AGENDA
REGULAR MEETING OF THE
WINDSOR HEIGHTS BOARD OF ADJUSTMENT
Wednesday, March 1, 2023 - 5:30 PM
WINDSOR HEIGHTS COUNCIL CHAMBERS - 1133 66th ST

STAFF REPORT

SILVERSTAR CARWASH
6300 HICKMAN RD
WINDSOR HEIGHTS, IOWA

Drawn By	JLV
Checked By	SMH
Date	01-26-2023
Scale	As Shown
Project No.	10904-0017
SHEET	C1.0

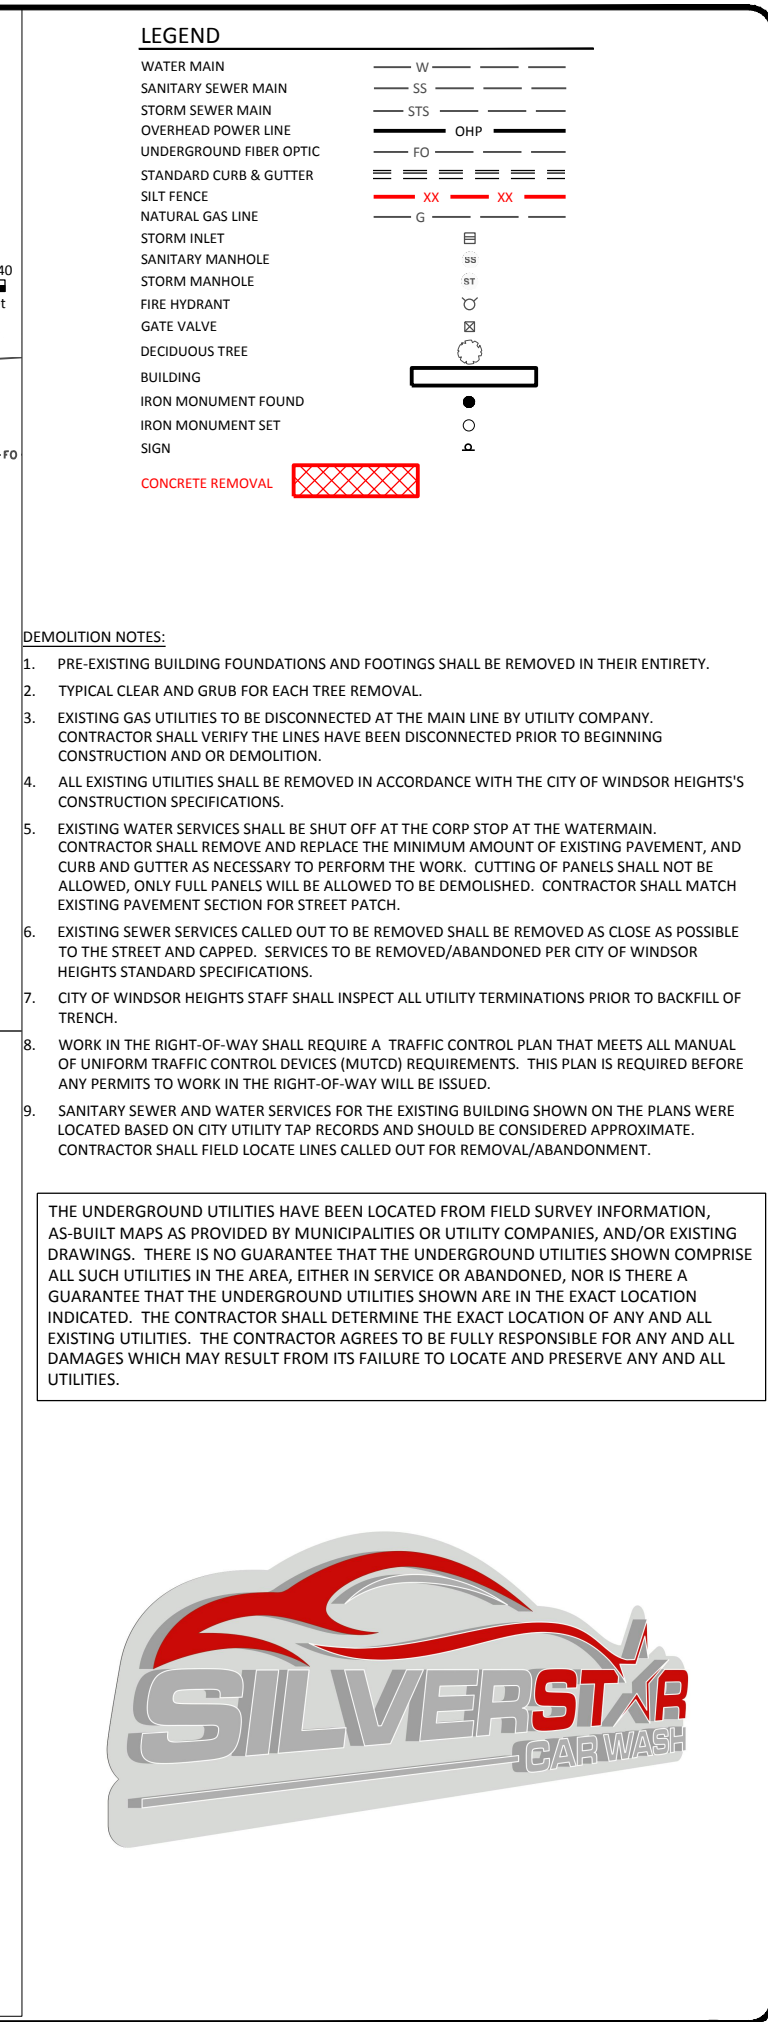
b. Sheet C1.0

- i. Label contour lines.
- ii. Hard to see the contour lines.
- iii. Show water main.
- iv. An existing light is not shown that is to the west of the driveway off Hickman Road. Light will need to be relocated.

Drawn By
JLV
Checked By
SMH
Date
01-26-2023
Scale
As Shown
Project No.
10904-0017
SHEET
C3.0

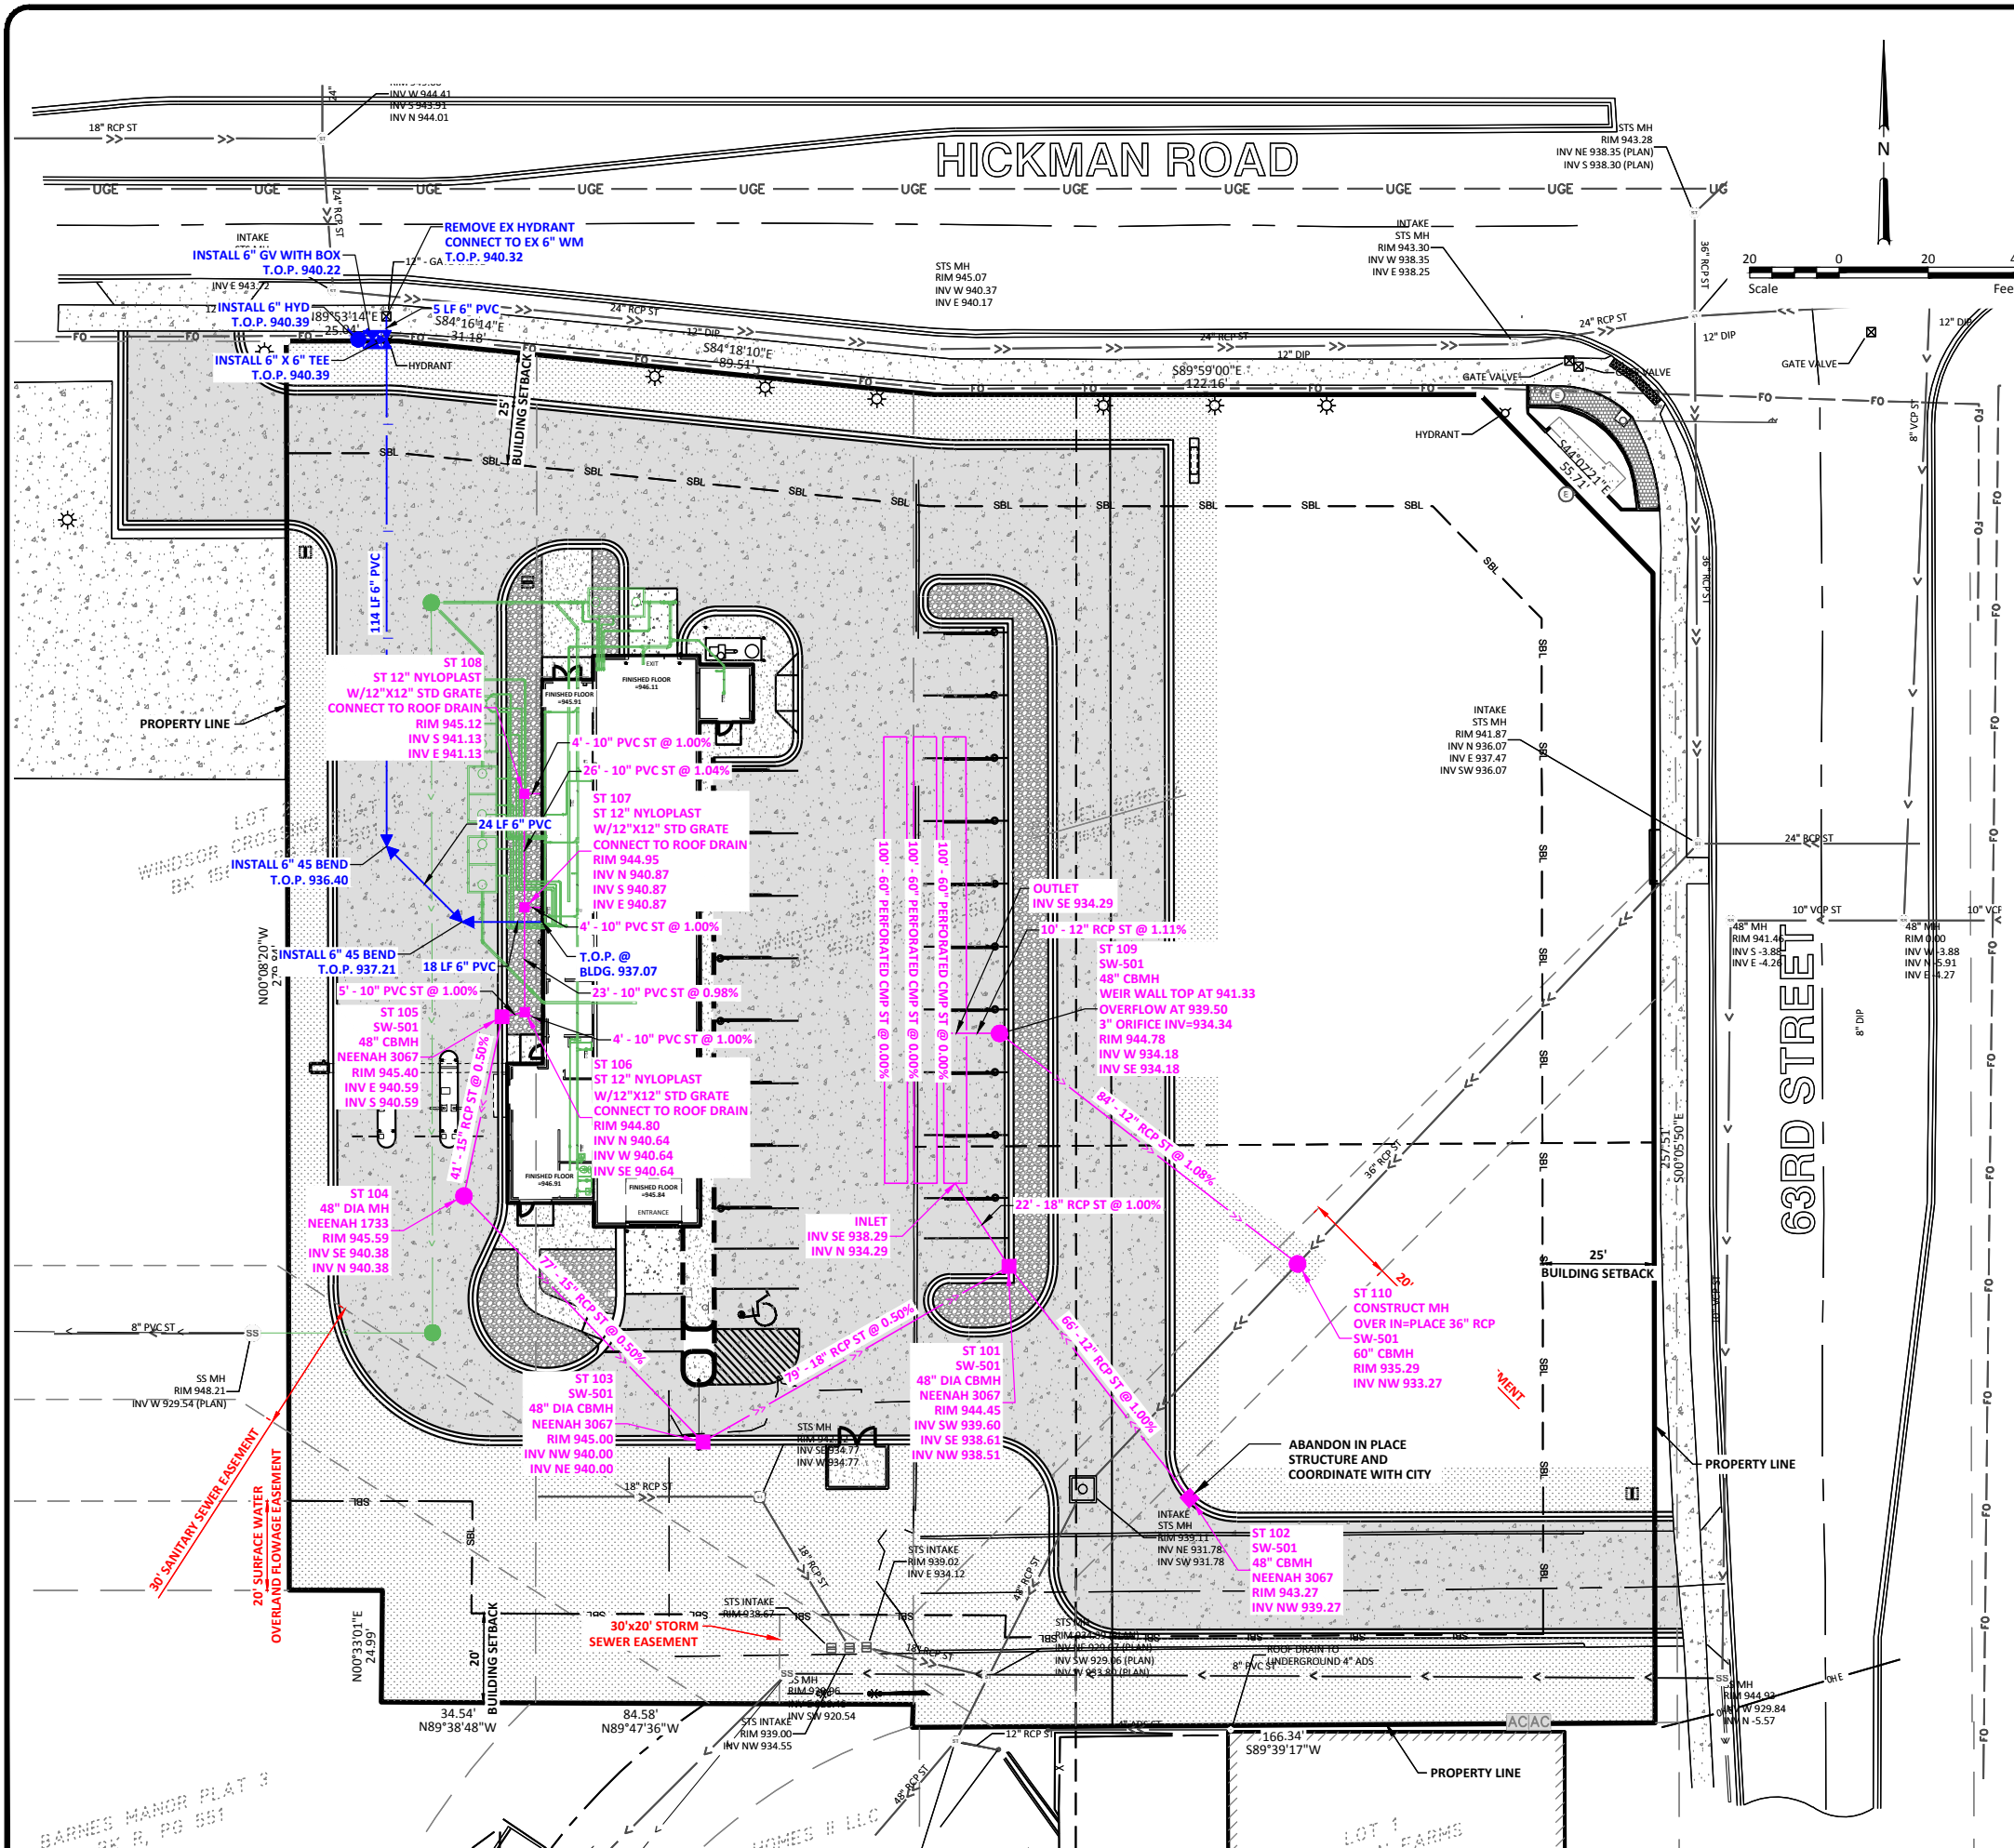
- i. Show removal of trail to make water service connection.
 - d. Sheet C3.0
 - i. Add a note that connection to existing sanitary manhole to be water-tight.

- ii. Connection elevation shall be 0.1 feet above the out flow elevation and a new flow channel needs to be made.
 - e. Sheet C3.1
 - i. What will happen to the existing intake?
